Title of Change:	TOLL packages alternative option ATX WEIHAI, China (ATXWH).
Effective date:	15 Feb 2024
Contact information:	Contact your local onsemi Sales Office or Daryl.Cruz@onsemi.com
Type of notification:	This Product Bulletin is for notification purposes only. onsemi will proceed with implementation of this change upon publication of this Product Bulletin.
Change Category:	Test Change, Assembly Change
Change Sub-Category(s):	Manufacturing Site Addition

This Product Bulletin is the follow up of IPCN24870Z announcing ATX WEIHAI, China (ATXWH) has been qualified as an additional Assembly and Test Operations manufacturing site of H-PSOF8L (TOLL) packages as listed below.

H-PSOF8L 9.90x10.38x2.30
CASE 100BQ
ISSUE O

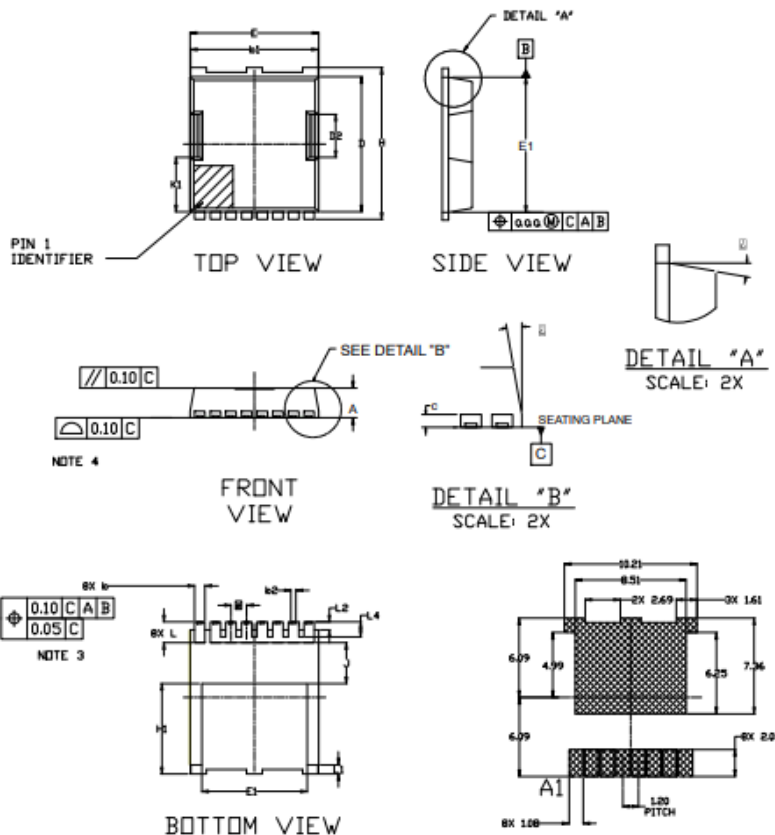
Current BOM	Additional BOM
Assembly	onsemi Cebu, Philippines	ATX Weihai, China
Lead frame	LF NA PackTypeL CKFC STAMPED	TOLL T-post Ni/NiP Plating
Adhesion Promoter	DA PRMTR AP8000	DA PRMTR AP8000
Die attach solder	95.5Pb2Sn2.5Ag	95.5Pb2Sn2.5Ag
Bonding wire	Aluminium wire 5mil & 20mil	Aluminium wire 5mil & 20mil
Mold Compound	CEL-9240HF 10LS	EME-G700LH
Case outline #	100CU	100BQ
Final Test	onsemi Cebu, Philippines	ATX Weihai, China
